Inspection of Automatic Sprinkler System

(Techniplas) Frotek East London
Industrial Development Zone

UNC8483

08.05.2024 15:40 SAST

Photo 2

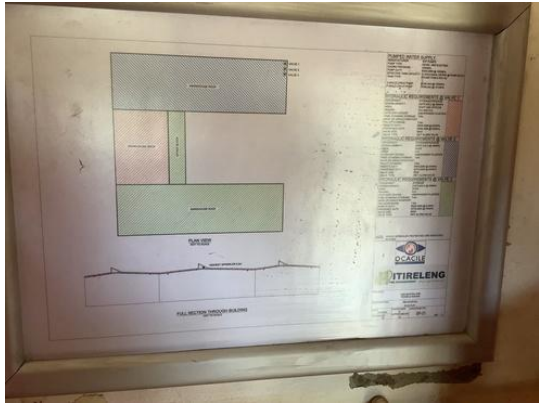
North west corner of building
